Access Compliance Report

Public Rights-of-Way

(Curb Ramps)

Intersection ID: 12589	Main Street: BELVEDERE_AV	Cross Street: TRUMAN_RD	Location: NE
ADA ID: 900DFCB802FF	Ramp Type: PerpDiag	Initial Pass/Fail: Fail	Overall Compliance: No
Codes/Mitigation Info/Possible Solution		Field Measurements/Component Compliance	
Severity Score: 21.25

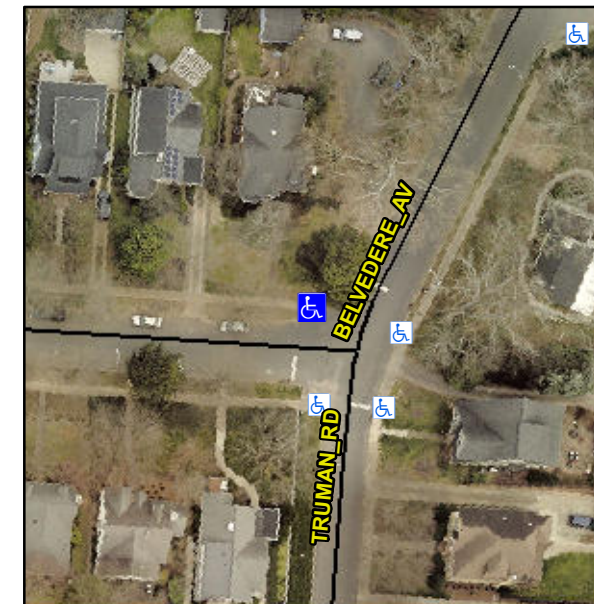
Remove & Replace Curb Ramp With Two New Directional Ramps or Equivalent.

R304.5.1, R304.5.3

Compliance	Description	Data	Compliance	Description	Data
N/A	Ramp Length (in)	67.0	Yes	Ramp Slope (%)	5.6
No	Ramp Width (in)	39.0	No	Ramp XSlope (%)	6.5
N/A	Flare Type LT	N/A	N/A	Flare Type RT	N/A
N/A	Flare Slope LT (%)	N/A	N/A	Flare Slope RT (%)	N/A
N/A	Flare Traversable LT?	N/A	N/A	Flare Traversable RT?	N/A
N/A	Landing Length (in)	N/A	N/A	DWS Provided?	N/A
N/A	Landing Width (in)	N/A	N/A	DWS Contrast?	N/A
N/A	Landing Slope (%)	N/A	N/A	DWS Length (in)	N/A
N/A	Landing X Slope (%)	N/A	N/A	DWS Full Width?	N/A
N/A	Landing Curb? (Y/N)	N/A	N/A	DWS Offset (in)	N/A
N/A	Shared Landing?	N/A			
N/A	Gutter Ponding?	N/A	N/A	Gutter Slope (%)	N/A
N/A	Gutter Lip Ht (in)	N/A	N/A	Gutter X Slope (%)	N/A
N/A	Painted X Walk1?	No	N/A	Painted X Walk2?	No
	X Walk 1 Direction	To S		X Walk 2 Direction	To E
N/A	X Walk 1 Width (in)	N/A	N/A	X Walk 2 Width (in)	N/A
	X Walk 1 Slope (%)	5.4		X Walk 2 Slope (%)	0.8
	X Walk 1 X Slope (%)	2.9		X Walk 2 X Slope (%)	4.4
